## **7.0 Instrumentation and Control Systems**

The information in this section of the reference ABWR DCD, including all subsections and tables, and figures, is incorporated by reference with the following departures and supplements.

## STP 3 & 4

# Final Safety Analysis Report

Figure 7.1-1 SSLC Self-Test System Diagnosis

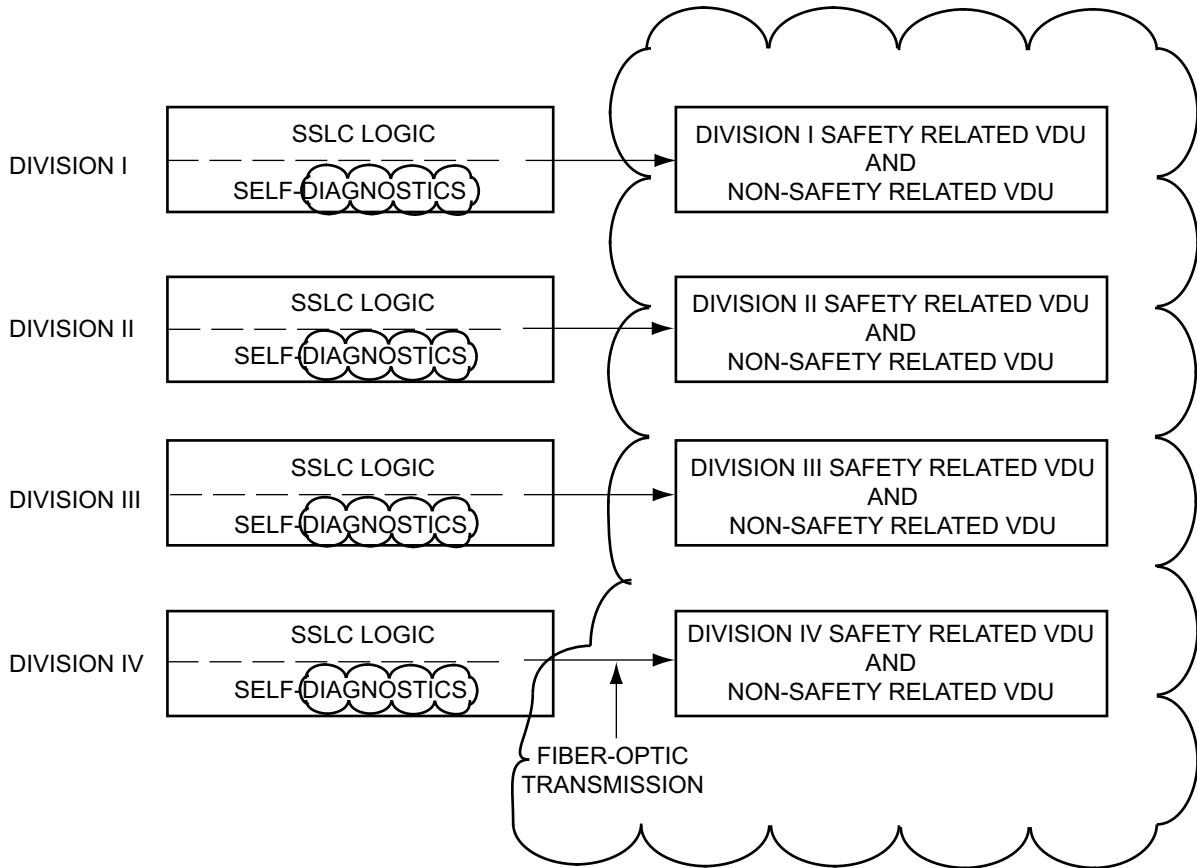
STD DEP T1 3.4-1 (Figure 7.1-1, 7.1-2)

STD DEP T1 3.4-1

*Each individual safety-related system utilizes redundant channels of safety-related instruments for initiating safety action. The automatic decision making and trip logic functions associated with the safety action of several safety-related nuclear steam supply systems (NSSS) are accomplished by ~~a four division correlated and separated protection logic complex called the~~ safety system logic and control (SSLC). The SSLC includes multiple redundant divisions, which are separated from each other. The SSLC has four redundant divisions of sensors. Each division of sensors has a corresponding division that determines the trip status of the safety functions relative to the safety function setpoint. The SSLC has four redundant divisions for all actuation functions except for the engineered safety features. The engineered safety features have three divisions, corresponding to the maximum redundancy of the engineered safety features actuated components. Some engineered safety features functions are less than three-fold redundant and are assigned to the appropriate set of redundant divisions. The SSLC multi-divisional complex includes divisionally separate control room and other panels which house the SSLC equipment for controlling the various safety function actuation devices. The SSLC receives input signals from the redundant*

Figure 7.1-2 Assignment of Interfacing Safety System Logic to SSLC Controllers

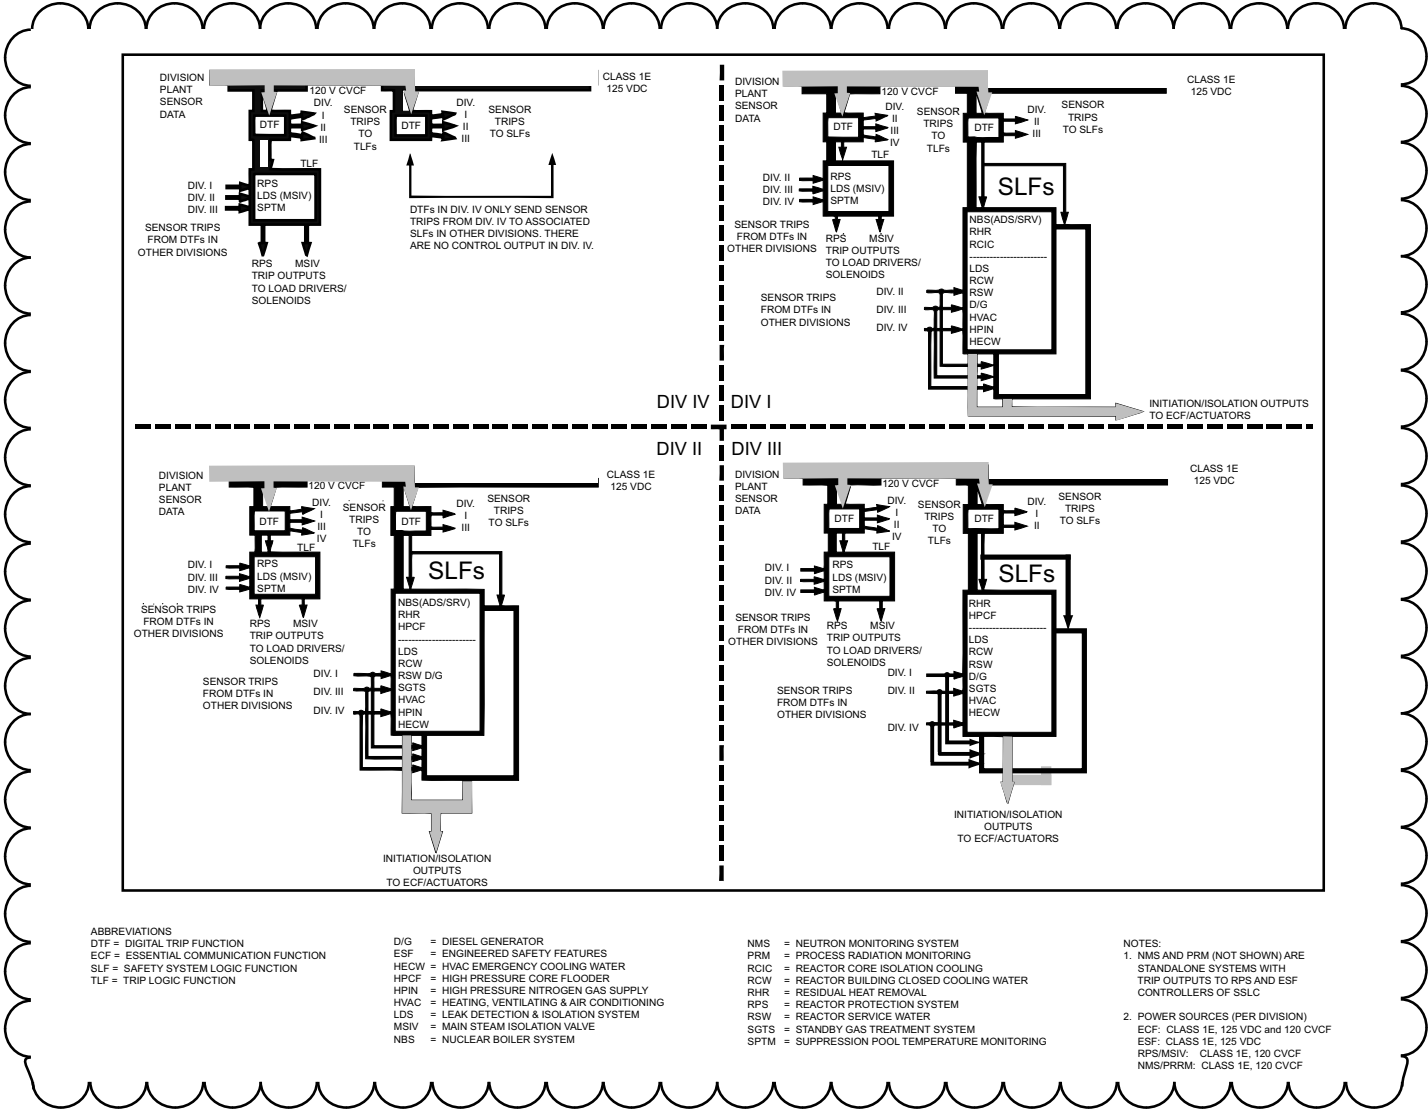
~~Divisional separation is also applied to the essential multiplexing system (EMS), which provides data highways for the sensor input to the logic units and for the logic output to the system actuators (actuated devices such as pump motors and motor-operated valves).~~ Systems which utilize the SSLC are include: (1) Reactor Protection (trip) System; (2) High Pressure Core Flooder System; (3) Residual Heat Removal System; (4) Automatic Depressurization System; (5) Leak Detection and Isolation System; (6) Suppression Pool Temperature Monitoring System; and (7) Reactor Core Isolation Cooling System. The equipment arrangement for these systems and other supporting systems is shown in Figure 7.1-2.
